UNITED STATES ENVIRONMENTAL PROTECTION AGENCY
WASHINGTON, D.C. 20460

WASTE CHARACTERIZATION REPORT

EPA TIER 1 EVALUATION

ADDITION OF WASTE STREAM IN-ID-NRF-153

Figure 1. Flow Diagram of the Characterization Process: IN-ID-NRF-153

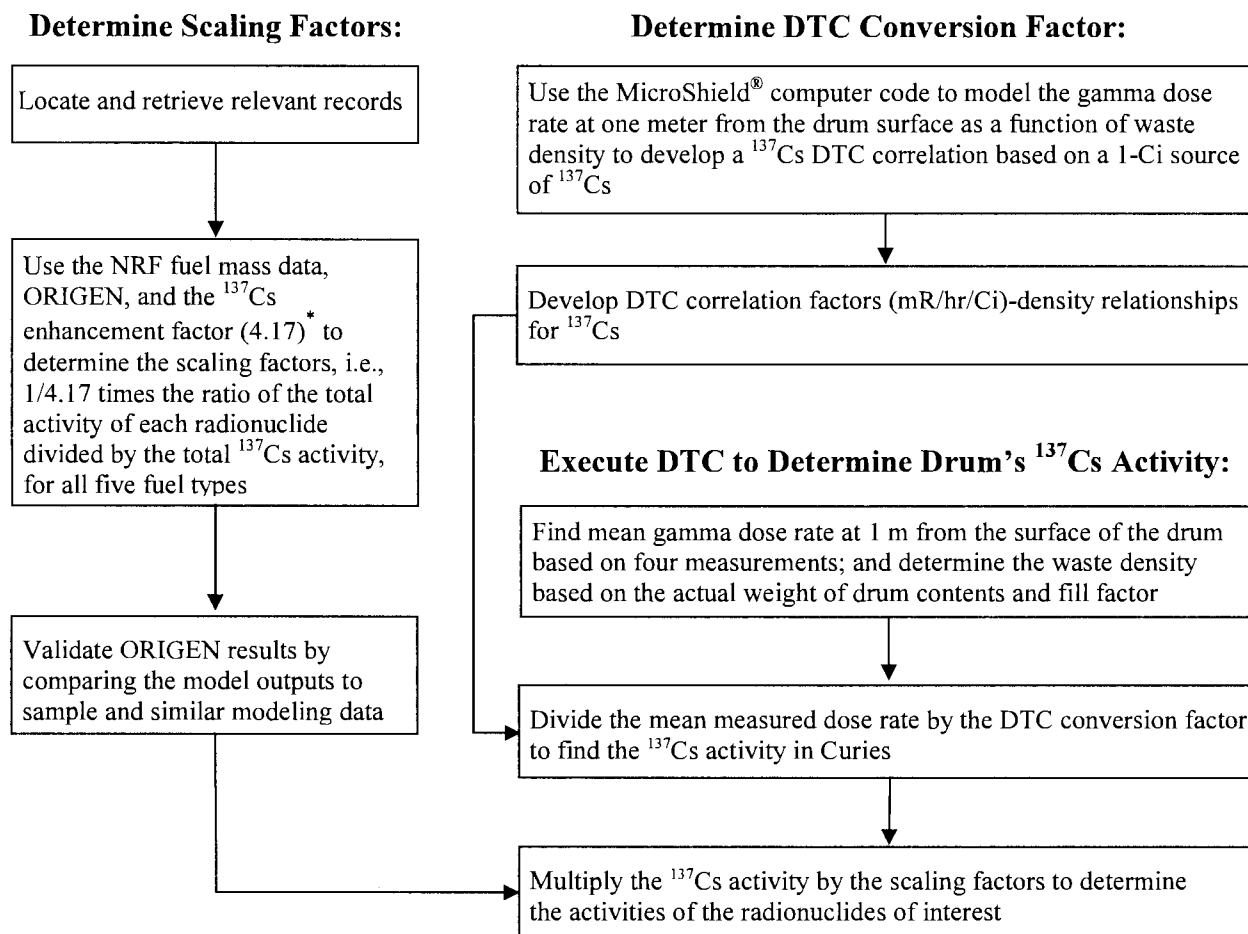
The waste sampling results were used as confirmation data to qualify the NRF radiological data, not to determine the scaling factors, as "only three of the five fuel types expected in the waste stream were detected on the waste samples" (CCP-AK-INL-560, Revision 2). The information obtained from samples was also used to determine whether and to what extent the ^{137}Cs remained in the fuel matrix (^{137}Cs partitioning). An overview of the radiological characterization process used for the IN-ID-NRF-153 wastes is provided in Figure 1, below.
